Product information - BMW brake pads | HELLA

BMW brake pads

8DB 355 009-271 / 8DB 355 015-391

New allocation of the brake pads

Mounting instructions

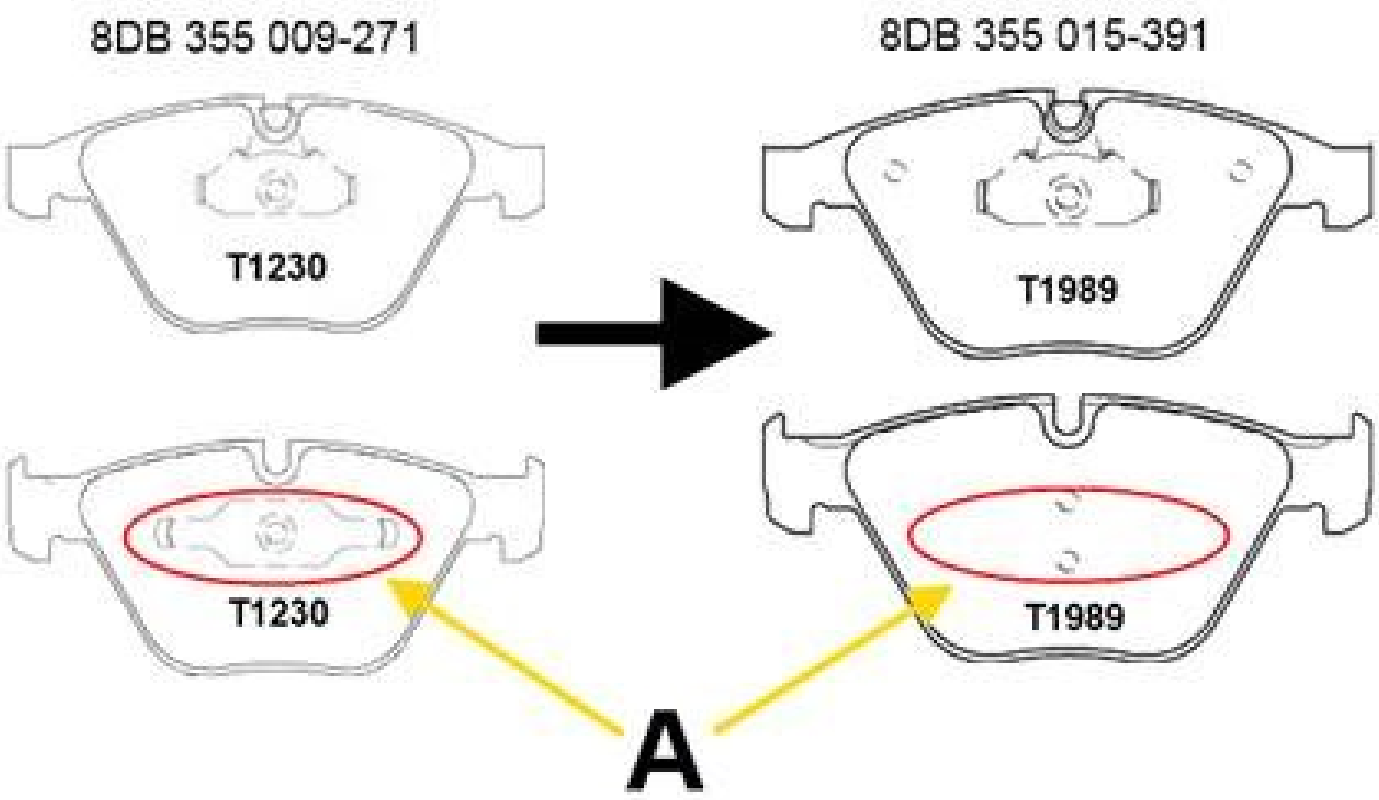
The difference between both brake pads is the missing retaining spring (A) on the brake pad 8DB 355 015-391 / T1989 on the fist side.

Brake pads 8DB 355 009-271 / T1230 shall still be used for the M models of the 1 series (E82) and 3 series (E90-91).

All other models are now covered by 8DB 355 015-391 / T1989. 8DB 355 015-391 / T1989 can also be retroactively used for all vehicles linked.
